Technical Bulletin

Distribution:	Application Engineers, Technical Support Engineers, Vision Solutions Engineers, Technical Documentation Group, Worldwide Sales	☐ INTERNAL ONLY
Bulletin No.:	TB-08-002	☒ Internal & Customers (as needed)
Date:	05/08/2008	☐ Internal & Customers (MANDATORY)
Product:	VISIONPRO	Rev: 5.0
Title: DCAM Doctor Security Problem Prevents Image Acquisition

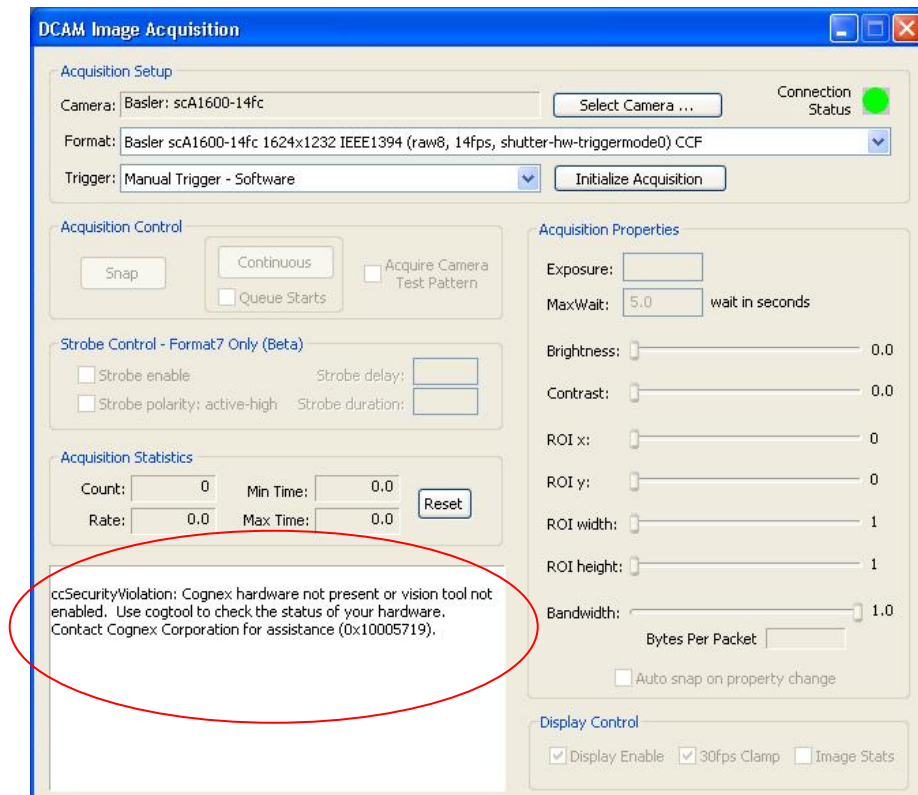
The first issue occurs when attempting to perform an image acquisition with DCAM Doctor version 1.0.0.3 that is supplied with VisionPro 5.0. You may receive a security violation as shown:

The message is a security violation on DCAM Doctor's Acquisition Setup dialog box when the Initialize Acquisition button is clicked. The message is as follows: "ccSecurityViolation: Cognex hardware not present or vision tool not enabled. Use cogtool to check the status of your hardware. Contact Cognex Corporation for assistance (0x10005719)".

This message may appear even when the Vx1394DCAM or VxSWAcquisition security bit is present on your security dongle or frame grabber. You can determine what security bits are on your security device by using the utility called cogtool.exe that is supplied with VisionPro.

An updated DCAM Doctor utility **version 1.0.0.5** is required to resolve these problems.

Place this new version into your VisionPro installation directory: %VPRO_ROOT%\bin (typically located at C:\Program Files\Cognex\VisionPro\bin).
